Final decision

AusNet Services electricity distribution
determination

Attachment 2 – Capital expenditure

Figure A2.1 — BN11 performance

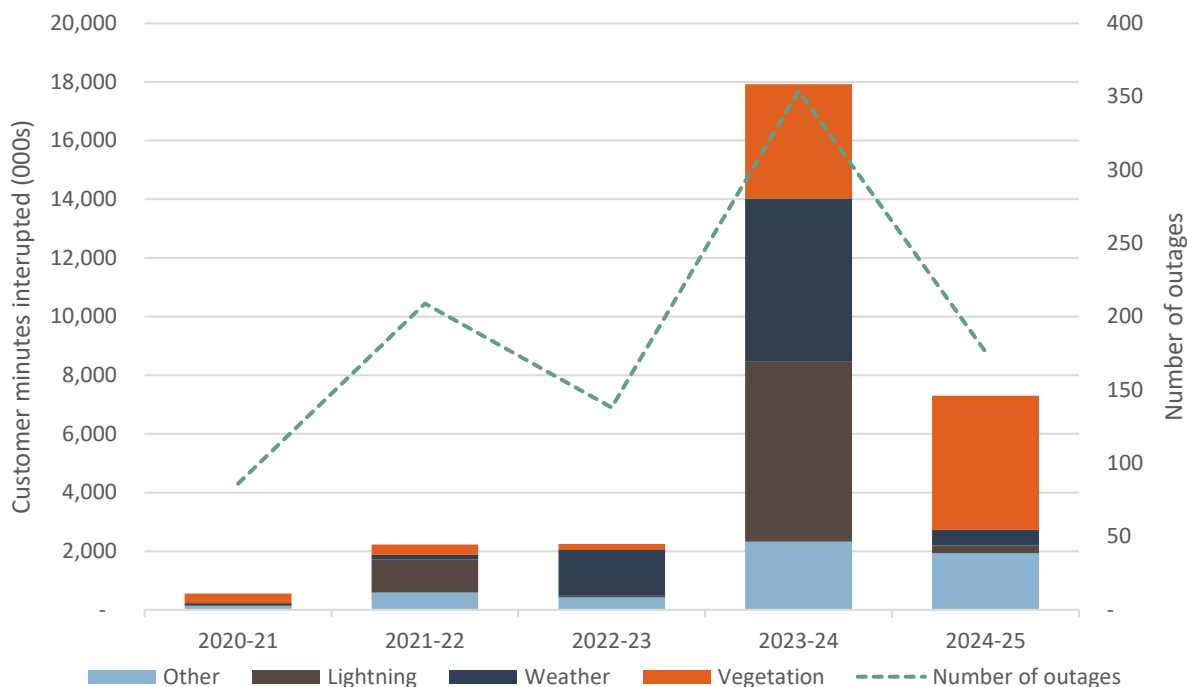
In the revised proposal AusNet undertook a root cause analysis which demonstrated that vegetation outages have been the primary driver of outages on this feeder over recent years, accounting for 63% of all customer minutes interrupted in 2024–25, followed by weather and lightning related outages. Further, since the introduction of the rapid earth fault current limiters, outages now affect more customers due to its inability to limit the outage to the fault

As shown below in Figure A2.1 the performance data reflects a material improvement in reliability performance in 2024–25 compared to the year prior. However, outage length in 2024–25 remains above historical levels.

AusNet’s modelling demonstrated that the express feeder is not expected to reduce the number of outages by addressing the root cause of reliability issues, rather, it will provide backup supply when there is a fault on the line between Benalla and Euroa.

Our forecast for reliability augmentation is \$7.2 million, which is 81.8% less than AusNet's revised proposal of \$39.7 million. This includes \$5.6 million for BN11 and \$1.7 million for the worst served feeder program.
